STAFF RECOMMENDATION

CASE FILE NO.: Z0365-19-D

PROPOSAL: Design review of proposed 16-unit development of attached townhouses along with associated site improvements.

Building Elevations

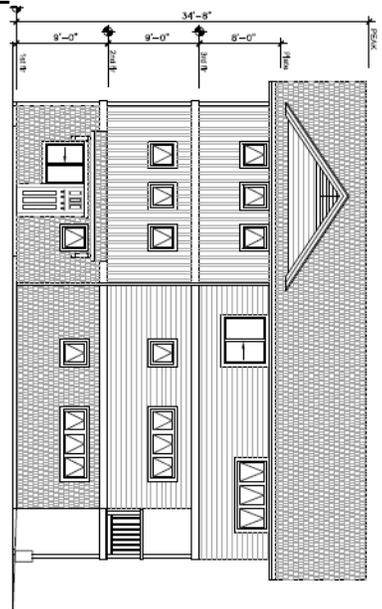
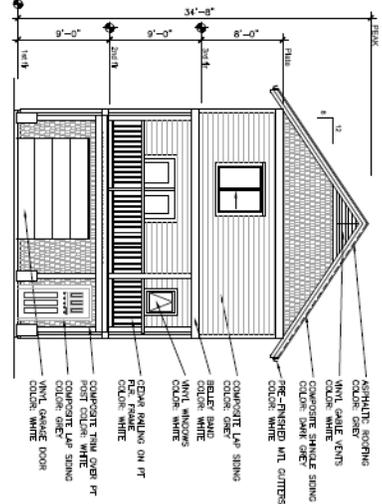
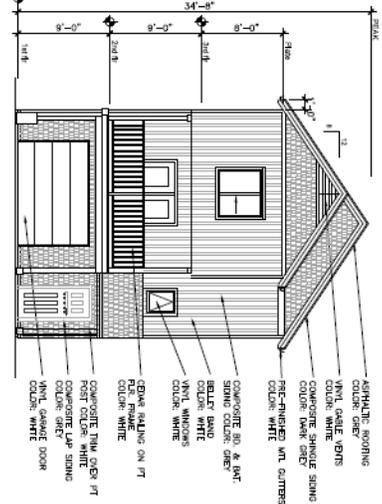
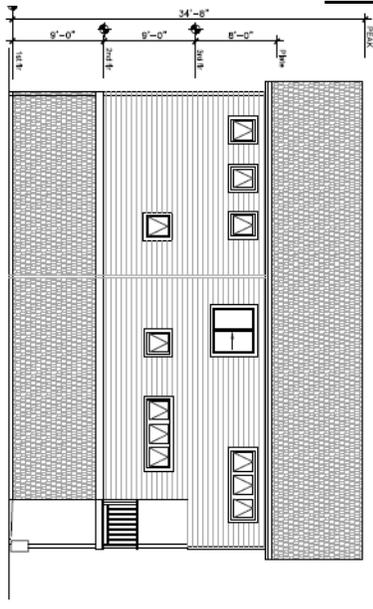
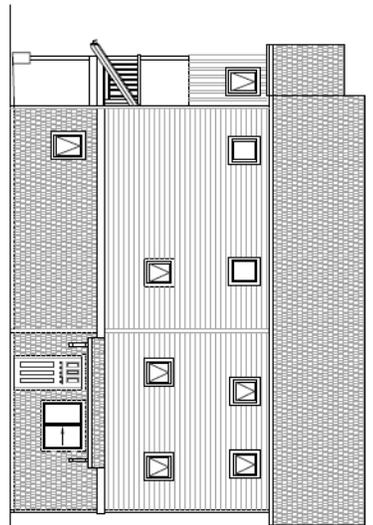
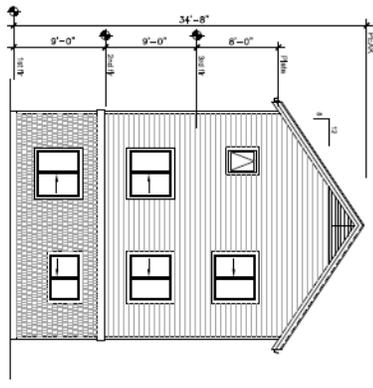
Finding: The proposed development provides articulation through alteration of plane, materials, color, and architectural detail such as doors and windows. The design creates relief, variety, and visual interest on the site. The proposed dwelling entrances are highlighted with a front porch or projecting roofline, along with landscaping as is common in a residential style. The use of windows, façade materials, color, trim, and other architectural features maintain a cohesive palette of materials that are complimentary and appropriate to the use and level of public exposure of the site as a whole. The Glencoe-facing unit features additional articulation of roof plane and enhanced transparency into the garage. The rhythmic repetitions of peaks of roof lines as a viewer looks down the shared driveway provides additional visual interest to the site and buildings. Per the above findings and the applicant's submitted drawings, the proposed building complies with the relevant standards of section 1005.04. These standards are met.
